Access Compliance Report

Public Rights-of-Way

Intersection ID: 10031235	Main Street: MARSH_RD	Cross Street: N/A	Location: SW
ADA ID: 1D9C56CA046C	Ramp Type: PerpDiag	Initial Pass/Fail: Fail	Overall Compliance: No
		Severity Score: 12.5

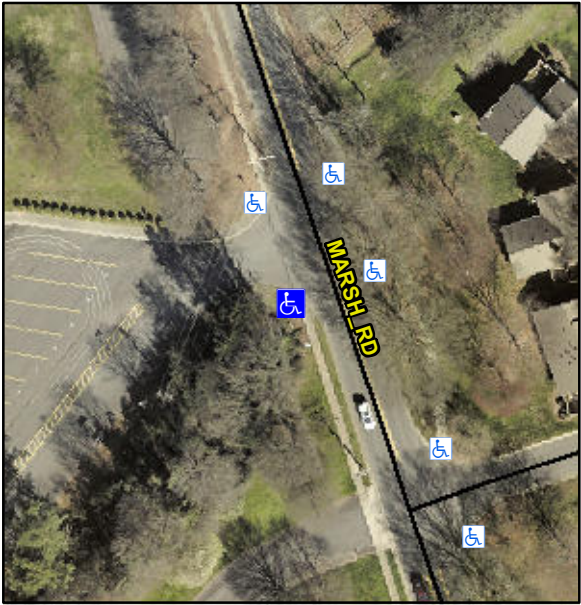
4.8	X Walk 1 Slope (%)	1.2
			1.0	X Walk 1 X Slope (%)	3.7
			N/A	Ramp inside XWalk1?	N/A
<p>Surveyor Notes:</p> <p>N/A</p> <p>PROW/ADA:</p> <p>Not Found, R304.5.3</p>			N/A	Ramp inside XWalk2?	N/A

Codes/Mitigation Info/Possible Solution			Field Measurements/Component Compliance		
	Possible Solutions:		Compliance	Description	Data
	Remove & Replace Curb Ramp With Two New Directional Ramps or Equivalent.		Yes	Ramp Length (in)	66.0
			N/A	Ramp Width (in)	89.0
			N/A	Flare Type LT	N/A
			N/A	Flare Slope LT (%)	N/A
			N/A	Flare Traversable LT?	N/A
			N/A	Landing Length (in)	N/A
			N/A	Landing Width (in)	N/A
			N/A	Landing Slope (%)	N/A
			N/A	Landing X Slope (%)	N/A
			N/A	Landing Curb? (Y/N)	N/A
			N/A	Shared Landing?	N/A
			N/A	Gutter Ponding?	N/A
			N/A	Gutter Lip Ht (in)	N/A
			No	Painted X Walk1?	N/A
			To E	X Walk 1 Direction	To N
			N/A	X Walk 1 Width (in)	N/A
